CITY OF JOLIET

ADDENDUM NO. 1

TO: Prospective Bidders for the 2020 Sidewalk/ Curb Replacement Project – Contract No. 2526-0920

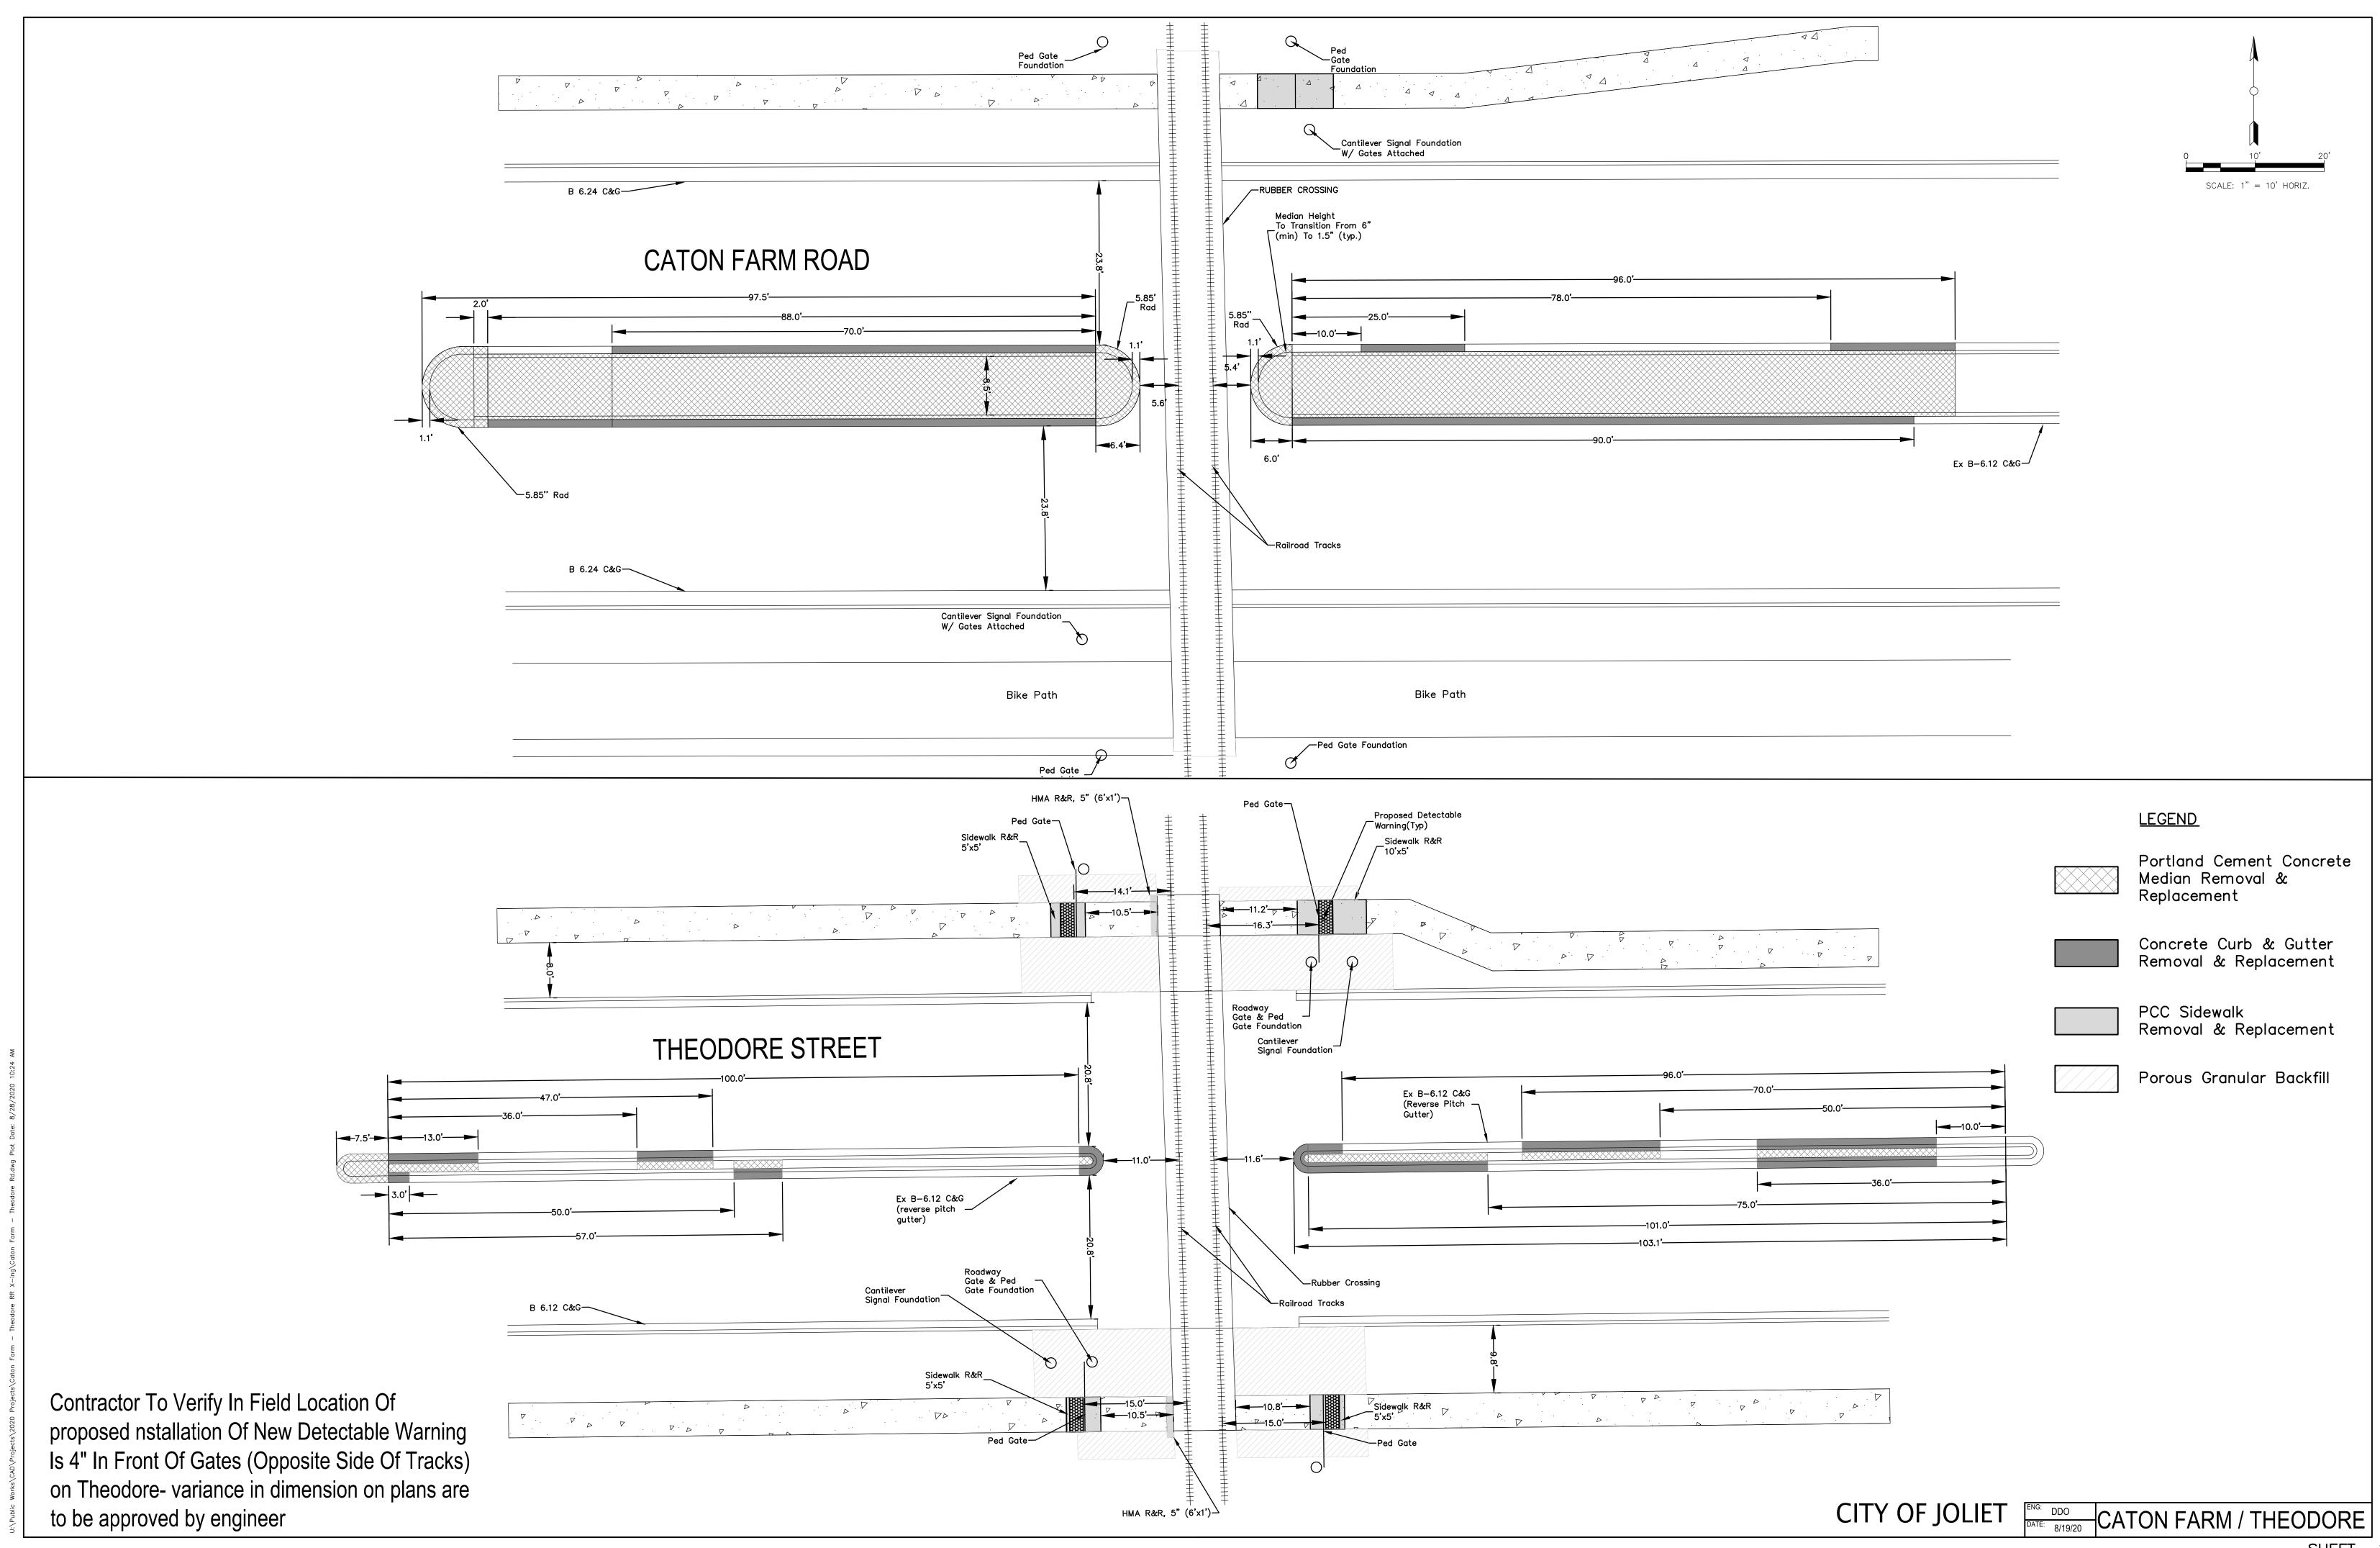
- 1. Attached is drawing for proposed curb and median replacement at Theodore St. and Caton Farm Rd. at the railroad tracks.
- 2. Two freight trains operate on the tracks per day at Theodore St. and Caton Farm Rd. crossings. The train timetable speed is 25 mph. No passenger trains use these tracks.
- 3. Service walk is to be removed and concrete step installed at 1122 Wilcox.
- 4. Attached is specification and detail for PCC Steps. PCC Steps item has been added to the Schedule of Prices.
- 5. Attached are the revised Schedule of Prices. Please remove the existing schedule of prices and insert the revised Schedule of Prices.

XX. PCC STEPS

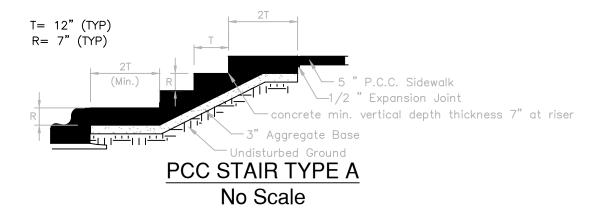
This work includes furnishing all material, equipment, and labor necessary to remove the existing material (including but not limited to aggregate, limestone, concrete, asphalt, and/or earth) and installing PCC steps per the "PPC Stair Type A" detail. This work shall be performed according to article 202, 311, 424 and 440 of the "Standard Specifications". The Steps shall be set on compacted 3" subbase granular material, Ty C. The riser height shall be maximum 7". The tread run length shall be minimum 11".
